Access Compliance Report

Public Rights-of-Way

(Curb Ramps)

Intersection ID: 52768	Main Street: SHOPTON_RD	Cross Street: NEW_FASHION_WY	Location: SW
ADA ID: DFC14EDE8DAB	Ramp Type: Perp	Initial Pass/Fail: Fail	Overall Compliance: No
Severity Score: 21.25			
Codes/Mitigation Info/Possible Solution		Field Measurements/Component Compliance

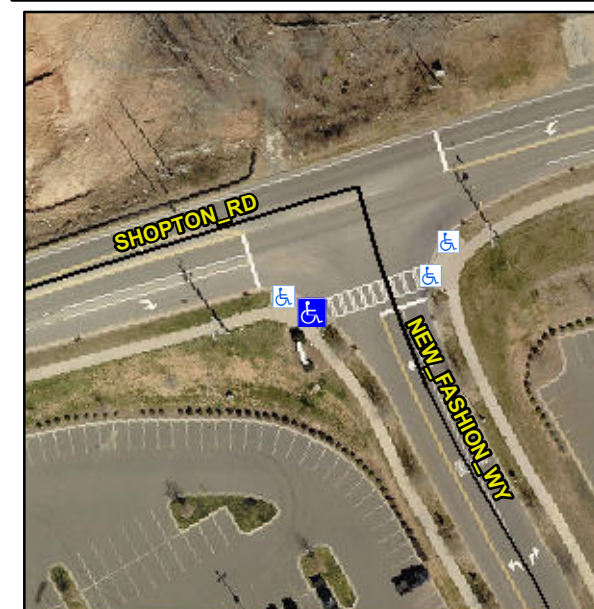
Not Found, R304.5.1, R304.5.3

Compliance	Description	Data	Compliance	Description	Data
N/A	Ramp Length (in)	95.0	Yes	Ramp Slope (%)	7.0
No	Ramp Width (in)	47.0	No	Ramp XSlope (%)	5.5
N/A	Flare Type LT	N/A	N/A	Flare Type RT	N/A
N/A	Flare Slope LT (%)	N/A	N/A	Flare Slope RT (%)	N/A
N/A	Flare Traversable LT?	N/A	N/A	Flare Traversable RT?	N/A
N/A	Landing Length (in)	N/A	N/A	DWS Provided?	N/A
N/A	Landing Width (in)	N/A	N/A	DWS Contrast?	N/A
N/A	Landing Slope (%)	N/A	N/A	DWS Length (in)	N/A
N/A	Landing X Slope (%)	N/A	N/A	DWS Full Width?	N/A
N/A	Landing Curb? (Y/N)	N/A	N/A	DWS Offset (in)	N/A
N/A	Shared Landing?	N/A			
N/A	Gutter Ponding?	N/A	N/A	Gutter Slope (%)	N/A
N/A	Gutter Lip Ht (in)	N/A	N/A	Gutter X Slope (%)	N/A
N/A	Painted X Walk1?	Yes	N/A	Painted X Walk2?	N/A
	X Walk 1 Direction	To E		X Walk 2 Direction	N/A
N/A	X Walk 1 Width (in)	120.0	N/A	X Walk 2 Width (in)	N/A
	X Walk 1 Slope (%)	1.9		X Walk 2 Slope (%)	N/A
	X Walk 1 X Slope (%)	6.9		X Walk 2 X Slope (%)	N/A

Remove & Replace Entire Ramp.
